Lower Thames Crossing

9.8 Environmental Statement Addendum (Clean version)

DATE: December 2023
DEADLINE: 10

Planning Inspectorate Scheme Ref: TR010032
Examination Document Ref: TR010032/EXAM/9.8

| Drawing Title | Figure 1 - ES Addendum update to information in figures and plates Page 1 of 11 | | | | |

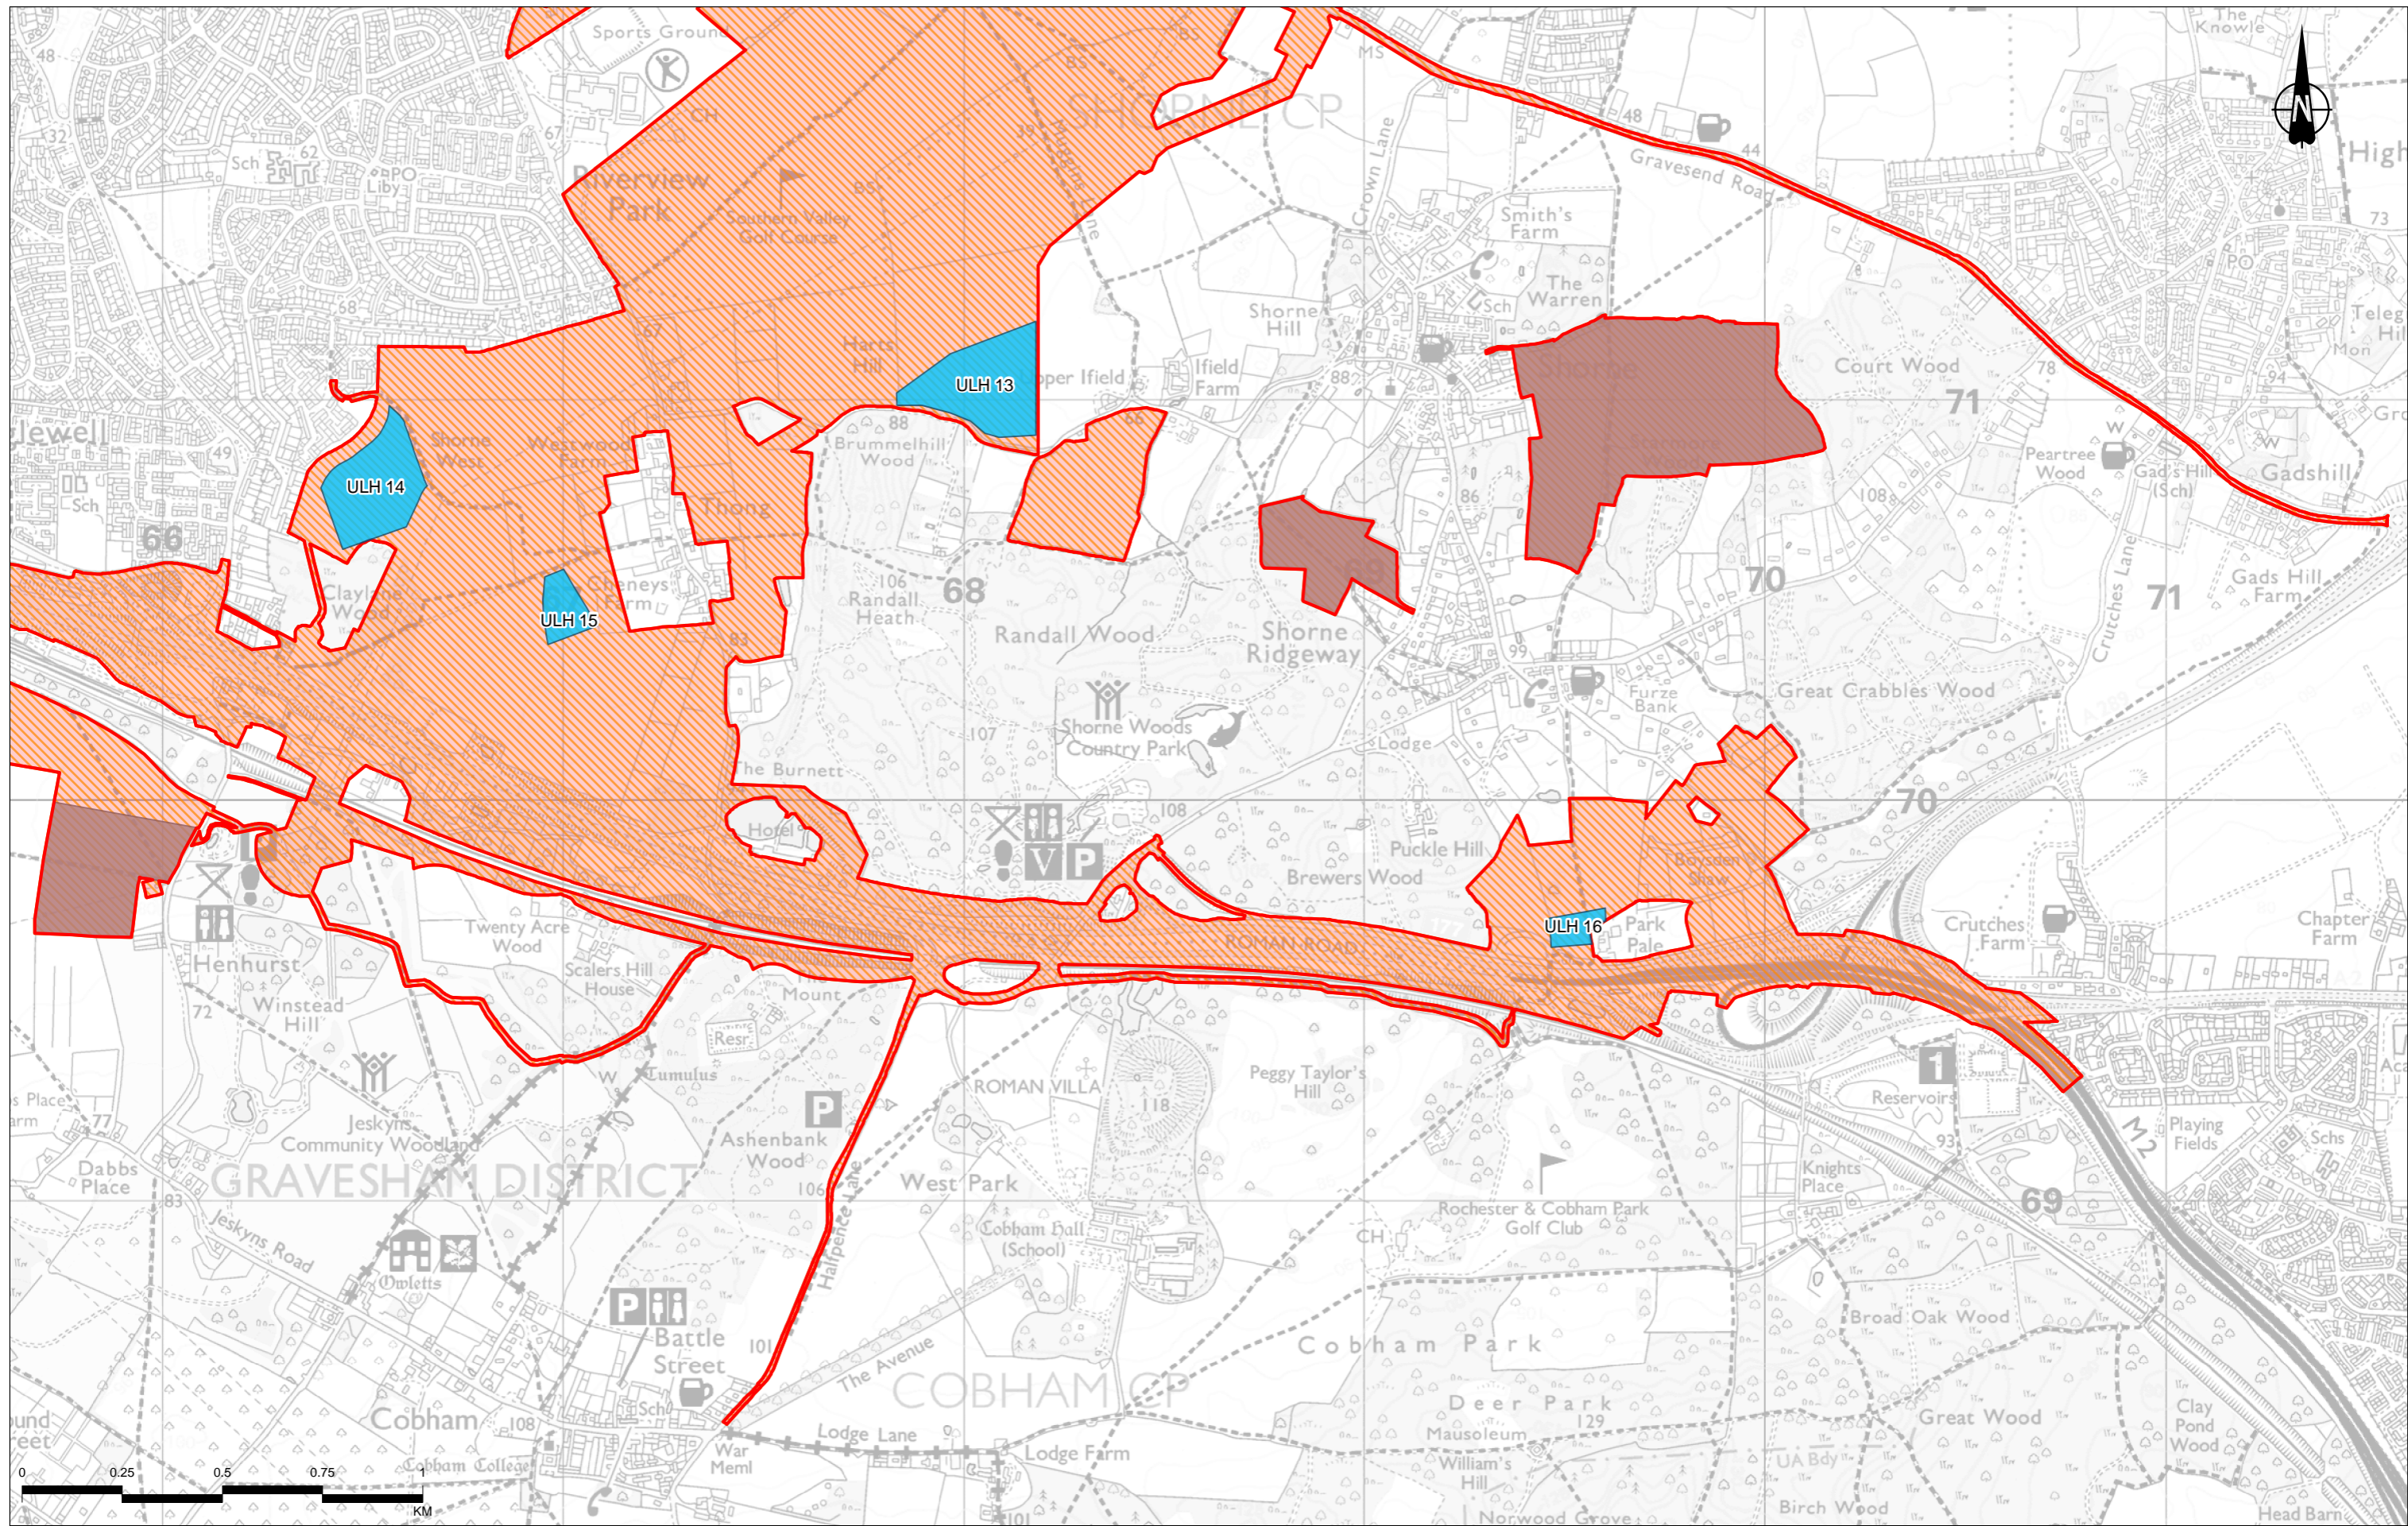
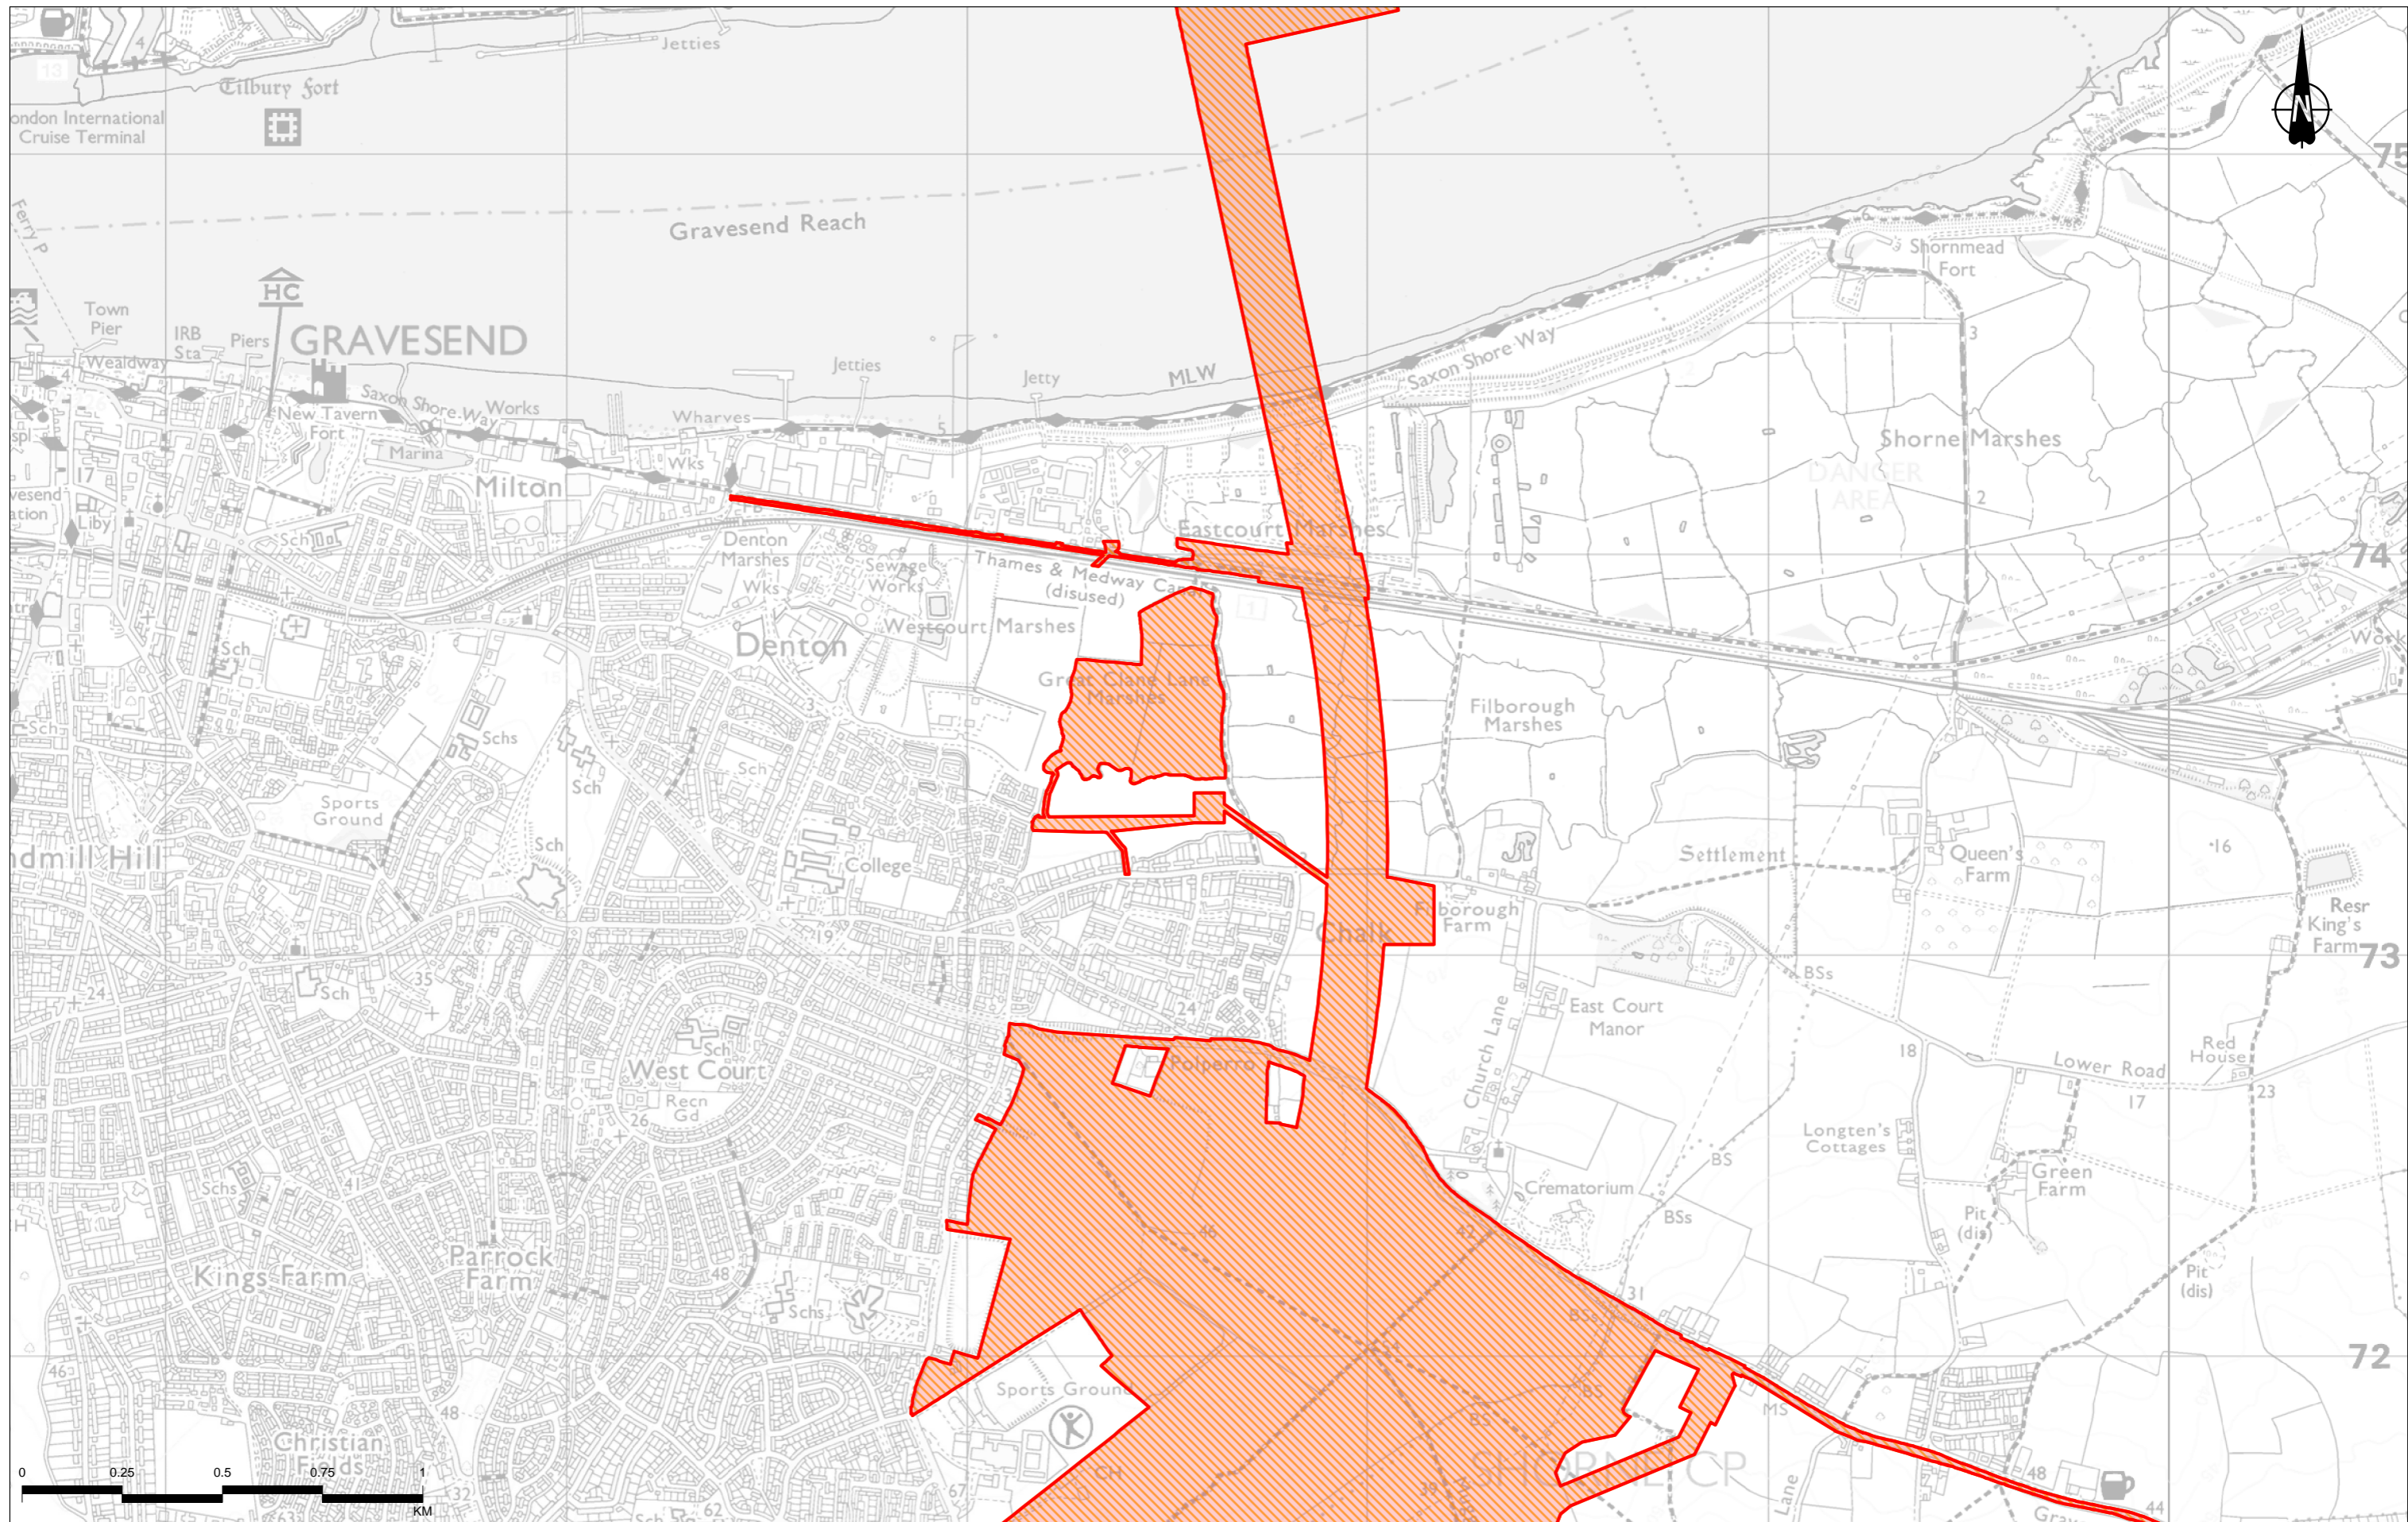
- 1.4.7 Updates to ES documents have been made reflecting changes to Order Limits. Where Order Limits are presented as an important feature supporting the understanding of the figure or plate, these have been shown in a new version of the document and submitted into Examination. Where the Order Limits are considered to be of less importance to the information presented in the figure or plate, for example, providing context to the location shown, these documents are updated via the information presented in this ES Addendum. To aid the understanding of the changes to Order Limits, Figure 1: ES Addendum update to information in figures and plates included in this ES Addendum, shows the original Order Limits as submitted in the DCO application in October 2022 and the final Order Limits as presented at Deadline 9. All figures and plates updated via the ES Addendum should be read with reference to Figure 1.

- 1.4.9 Similar to above, Figure 1 also shows the original and revised locations of the Muckingford Road and Low Street Lane Utility Logistics Hubs (ULH 11 and 12 respectively). As for the above, the record of updates in Section 3 identifies where documents containing this information should be read with reference to Figure 1.
